Superfund Record of Decision:

Oak Grove Landfill, MN

RECORD OF DECISION

C. SUMMARY OF PUBLIC COMMENTS RECEIVED DURING THE PUBLIC COMMENT PERIOD AND MPCA RESPONSES

ALTERNATIVE COVER SYSTEM 3A

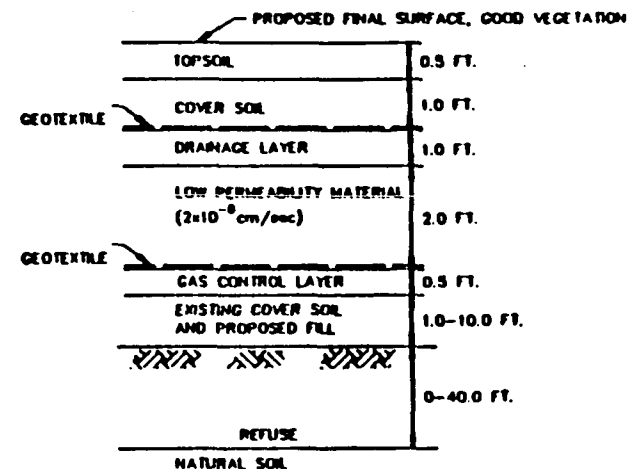
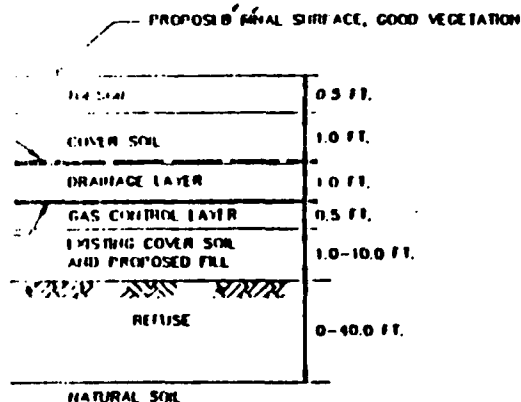
- requested that the existing lime sludge be graded before the fill is placed
- questioned whether gas venting would be provided
- questioned how surface runoff will be controlled
- requested that the quality of the upper 18 inches of soil meet county requirements
- questioned whether the use of the synthetic barrier is realistic because of the difficulty of repair after cover soils are placed
- requested that consideration be given to additional cover soils for frost protection

3. Both cover plans, 3A and 3B, provide for 2 1/2 feet of cover over the impervious material (low permeable soils or flexible membrane). Two and a half feet of cover may not provide sufficient protection of these materials from damage caused by freeze/thaw cycles. Consideration should be given to additional protective cover soils.

Frost control is not required for cover under Minnesota's proposed solid waste rules. The MPCA believes that the drainage layer in the cover system will remove a sufficient amount of moisture from the cover to prevent frost damage.
